**E3616A-03-S**

**S E R V I C E N O T E**

**E3616A Lab Bench DC Power Supply**

**POSSIBLE SHOCK HAZARD**

**CAUTION: TEST FOR LOOSE AC MODULE**

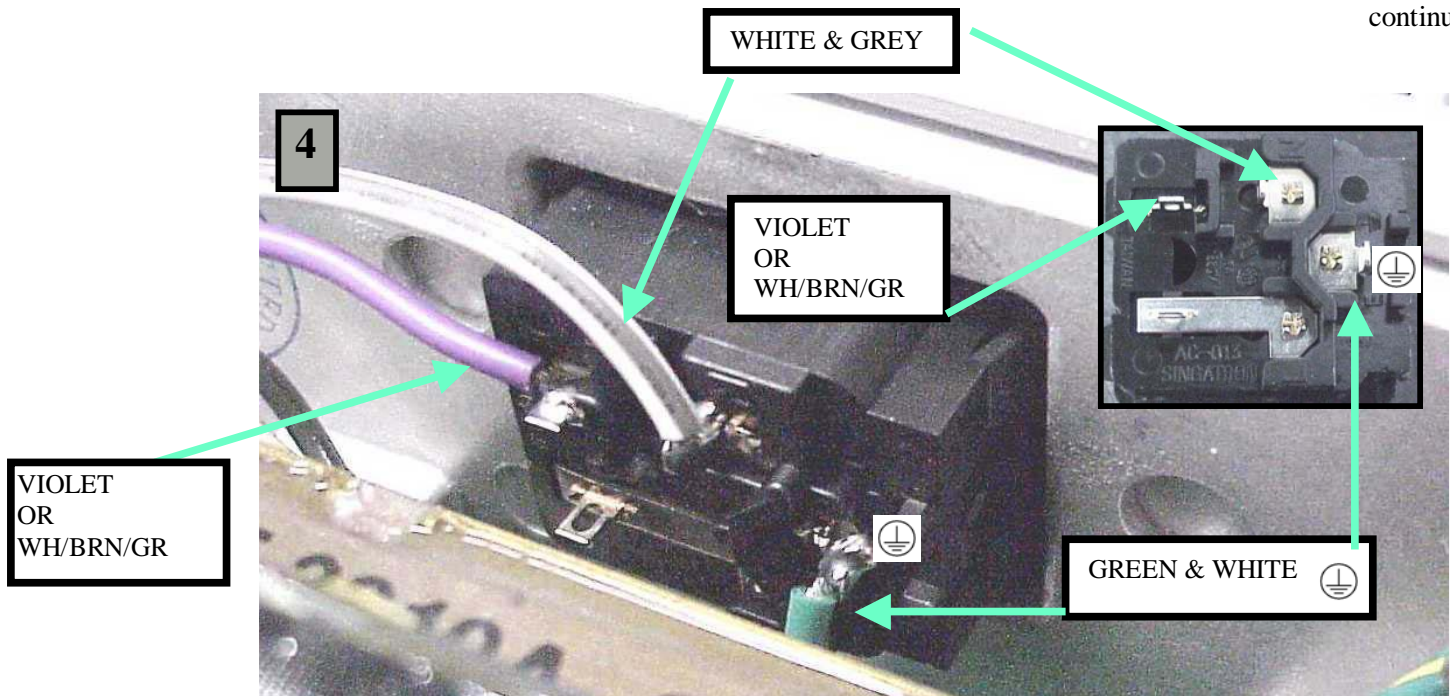
If the AC line cord is forcefully pulled in a side-to-side direction the AC Module can be pulled out of the rear heatsink, exposing the conductors that carry AC line voltage.

1. Make sure linecord is removed from outlet.
2. With linecord securely inserted in AC Module as shown, pull forcibly (2 times) in direction of arrow.

1. If the AC Module pulls out from Unit as shown it will need to be replaced.
2. If the AC Module remains in place it does not need to be changed. Put a mark on the AC input label in the lower left hand corner with indelible ink to indicate that the AC module has been checked. This label can be found below the AC module.

Pry Rear Bezel and Front Panel away from Cover in four places. Then lift Cover off unit.

Pry Tabs out on rear of Top Cover and lift Cover off of the unit

**REPLACE MODULE** with P/N 5065-6978. Before soldering perform “TEST FOR LOOSE AC MODULE” as shown in picture above. This will confirm that the new Module is secure. Solder wires and **REPLACE FUSE**.
